Office Action Summary	Application No.	Applicant(s)	
	10/572,534	TORO, ANTONIO	
	Examiner	Art Unit	
	ASHLEY KWON	1795

DETAILED ACTION

Drawings

Claims 1, 2, and 4 are rejected under 35 U.S.C. 102(b) as being anticipated by Condeescu et al. (WO 02/023645) (hereinafter “Condeescu”).

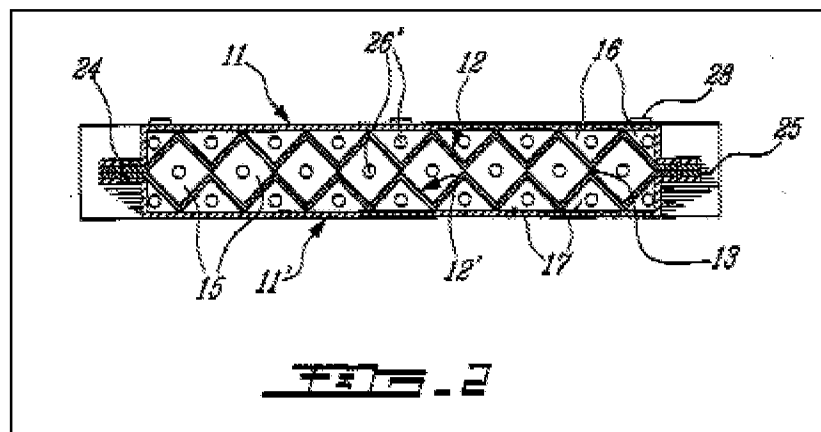
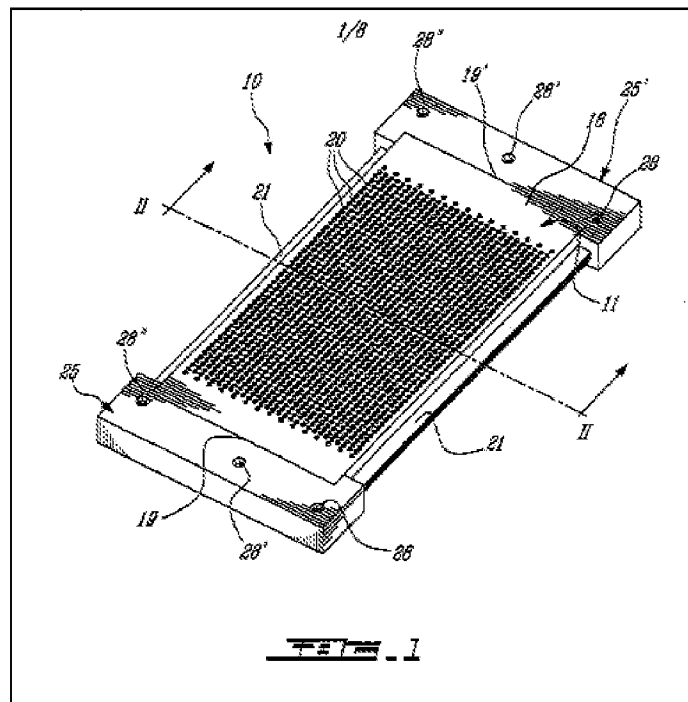
Regarding claim 1, Condeescu teaches a bipolar separator (bipolar separator plate assembly, 10) for a fuel cell stack, comprising a cathode sheet and an anode sheet (distributor plates 11, 11'), at least on of said sheet provided with fluid passage holes (perforated with holes, 20) (see pg. 5, lines 1-7 and 24-25; figs. 1 and 2); at least one corrugated conductive element (separator plates 12, 12'), wherein said cathode sheet and said anode sheet are welded through said at least one corrugated conductive element (separator plates 12, 12') (see pg. 6, lines 1-7) and wherein a cooling fluid passage (outer gas channel, 16 and 17) is formed between the corrugated conductive element and at least one of said cathode sheet and anode sheet. The flanges of the separator plates and distributor plates are welded together by longitudinal line resistance welding at 24 (see fig. 2, see pg. 6, lines 1-7), therefore said cathode and anode sheets (11 and 11') are welded through both the corrugated conductive elements (12 and 12'). Barring further specification of “a cooling fluid”, any gas or liquid will be interpreted as being able to function as a cooling fluid. Under this interpretation, a cooling fluid passage (16 and 17) is formed between the corrugated conductive element

Regarding claim 2, Condeescu teaches the separator of claim 2, wherein said fluid passage holes (holes, 20) are gas feed and/or discharge holes disposed in one or more peripheral regions of at least one sheet. Gas fed through the groups of gas channels (16 and 17) permeate through the holes (20) of the distributor plate (11) (see pg. 5, line 28-31). It is clearly shown in fig. 1 that the holes are placed throughout the sheet. Therefore this claim is anticipated.

Regarding claim 4, Condeescu teaches the separator of claim 1, wherein at least one corrugated conductive element (separator plates 12, 12') adjoins said cathode and anode sheets (distributor plates 11, 11') generally along the whole surface of the separator (see fig. 2) and said cooling fluid passage section (16 and 17) comprises channels delimited by the surface of said corrugated conductive element (see fig. 2).
